Access Compliance Report

Public Rights-of-Way

(Curb Ramps)

Intersection ID: 50635	Main Street: RED_WATER_RD	Cross Street: BLUE_BLOSSOM_RD	Location: NE
ADA ID: 582D55203007	Ramp Type: Perp	Initial Pass/Fail: Fail	Overall Compliance: No
Severity Score: 8.75			
Codes/Mitigation Info/Possible Solution		Field Measurements/Component Compliance

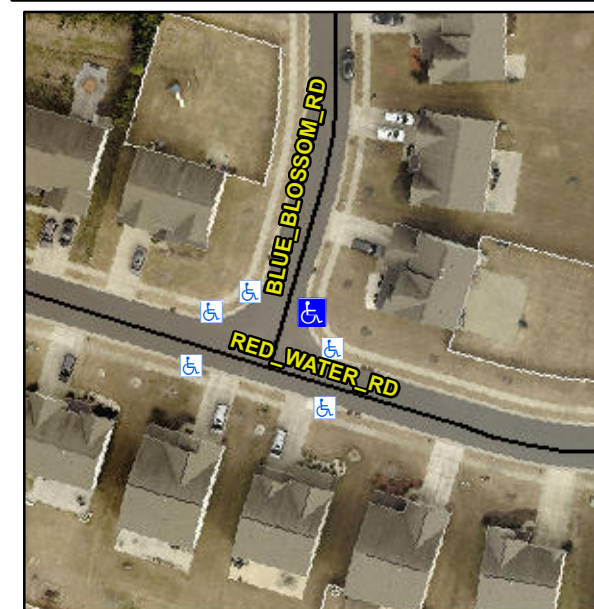
Not Found, R304.5.1

Compliance	Description	Data	Compliance	Description	Data
N/A	Ramp Length (in)	46.5	Yes	Ramp Slope (%)	6.7
No	Ramp Width (in)	46.0	Yes	Ramp XSlope (%)	1.7
N/A	Flare Type LT	N/A	N/A	Flare Type RT	N/A
N/A	Flare Slope LT (%)	N/A	N/A	Flare Slope RT (%)	N/A
N/A	Flare Traversable LT?	N/A	N/A	Flare Traversable RT?	N/A
N/A	Landing Length (in)	N/A	N/A	DWS Provided?	N/A
N/A	Landing Width (in)	N/A	N/A	DWS Contrast?	N/A
N/A	Landing Slope (%)	N/A	N/A	DWS Length (in)	N/A
N/A	Landing X Slope (%)	N/A	N/A	DWS Full Width?	N/A
N/A	Landing Curb? (Y/N)	N/A	N/A	DWS Offset (in)	N/A
N/A	Shared Landing?	N/A			
N/A	Gutter Ponding?	N/A	N/A	Gutter Slope (%)	N/A
N/A	Gutter Lip Ht (in)	N/A	N/A	Gutter X Slope (%)	N/A
N/A	Painted X Walk1?	No	N/A	Painted X Walk2?	N/A
	X Walk 1 Direction	To NW		X Walk 2 Direction	N/A
N/A	X Walk 1 Width (in)	N/A	N/A	X Walk 2 Width (in)	N/A
	X Walk 1 Slope (%)	0.6		X Walk 2 Slope (%)	N/A
	X Walk 1 X Slope (%)	2.5		X Walk 2 X Slope (%)	N/A

N/A	Ramp inside XWalk1?	N/A	N/A	Ramp inside XWalk2?	N/A
	Road Slope (%)	N/A	N/A	Clear Space?	N/A
	Road X Slope (%)	N/A	N/A	Clear Space to XWalk (in)	N/A
N/A	Any Obstructions?	N/A	N/A	Storm Grate/Utility Hazard?	N/A
	Obstruction Type			Storm Grate/Utility Type	
		N/A			N/A
		Yes		Surface Condition? (G/P)	Good

Remove & Replace Entire Ramp.
